Project No.158-211: Route 15 Safety Improvements, Resurfacing, Enhancements and Bridges Improvements in the Towns of Westport & Fairfield.

Project No.158-207: Rehabilitation of Bridge No. 00728 Merritt Parkway over the Saugtuck River in the Town of Westport.

NOVEMBER 14, 2016
MERRITT PARKWAY (ROUTE 15) SAFETY IMPROVEMENTS,
RESURFACING, ENHANCEMENTS, AND BRIDGE IMPROVEMENTS
FEDERAL AID PROJECT NOS.: 0015(134) & N/A
STATE PROJECT NOS.: 158-211 & 158-207
TOWNS OF WESTPORT & FAIRFIELD

ADDENDUM NO. 2

FIGURE 1:

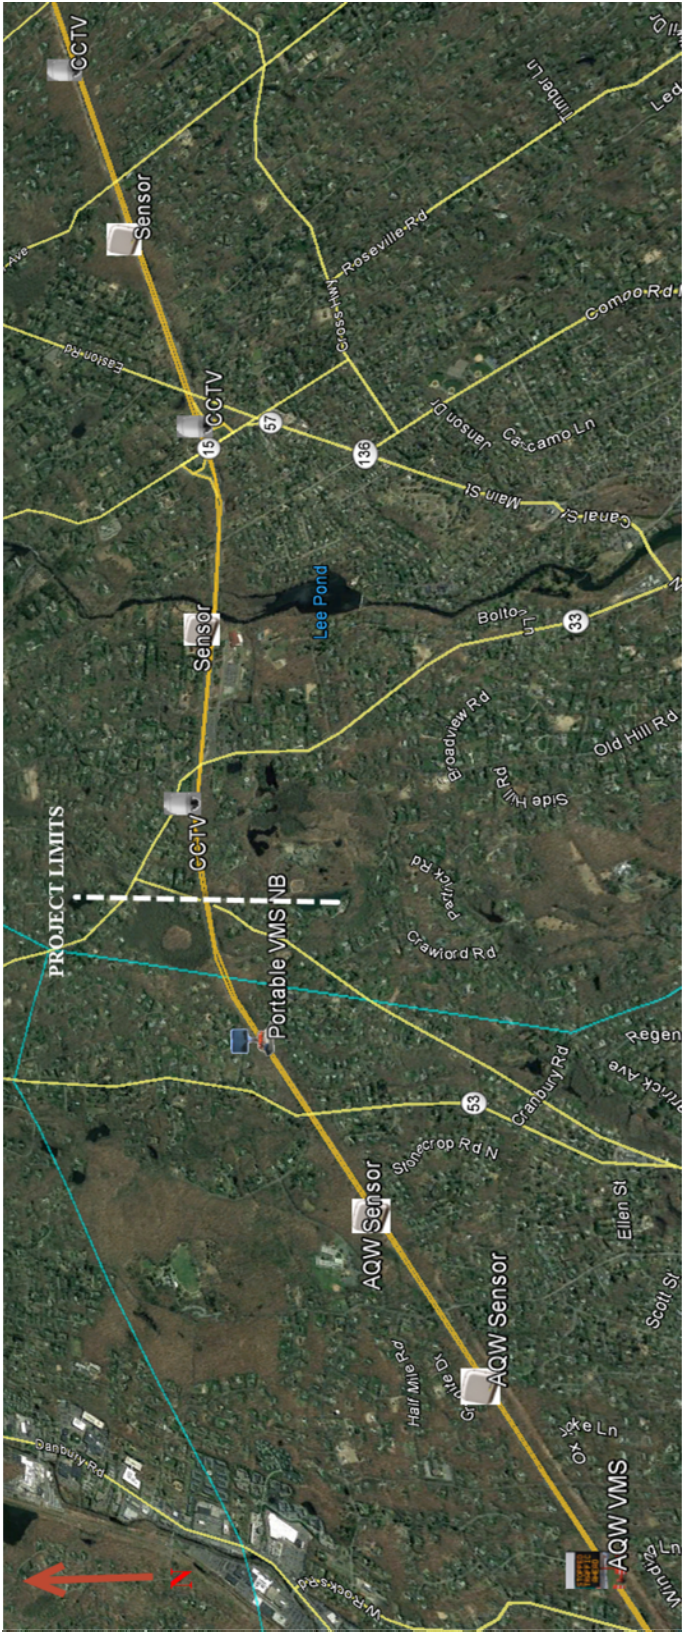
Figures 1 and 2 and Tables 1 and 2 are provided as a guide. Actual locations of the PWZMS equipment shall be determined in the field. The Engineer will review and approve final locations of the equipment.
